**Written submission from
Anna Tilman**

**BWXT Nuclear Energy Canada Inc.,
Toronto and Peterborough Facilities**

Application for the renewal of the licence for
Toronto and Peterborough facilities

**BWXT Nuclear Energy Canada Inc.'s Application for Renewal of its Class 1B
Operating Licence for a 10-year period**

Fig.1 Beryllium Concentration in Water (µg/L) Emissions -2011 to 2019⁸

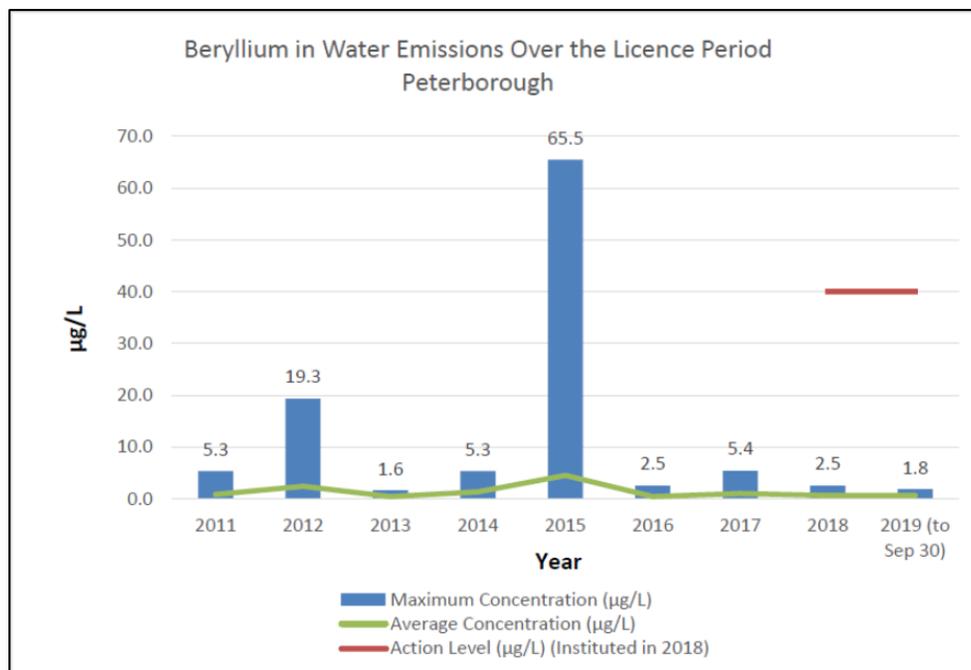
The Action Level is 40µg/L. For the year 2015, the maximum concentration is 65.6 µg/L while the average concentration is approximately 4µg/L. Can this be explained?

This graph also points out the impact of averaging emissions. Averages mask the necessary detail that would demonstrate anomalies.

Fig. 2 Toronto Uranium Emissions⁹

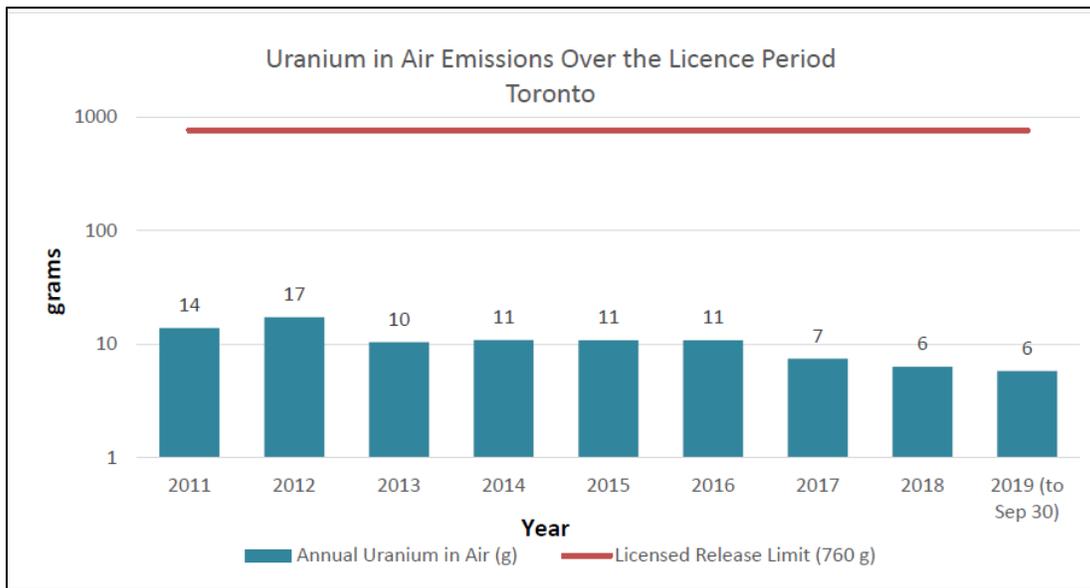
Note that the y-axis is a logarithmic scale in order to demonstrate the license limit of 760 g.
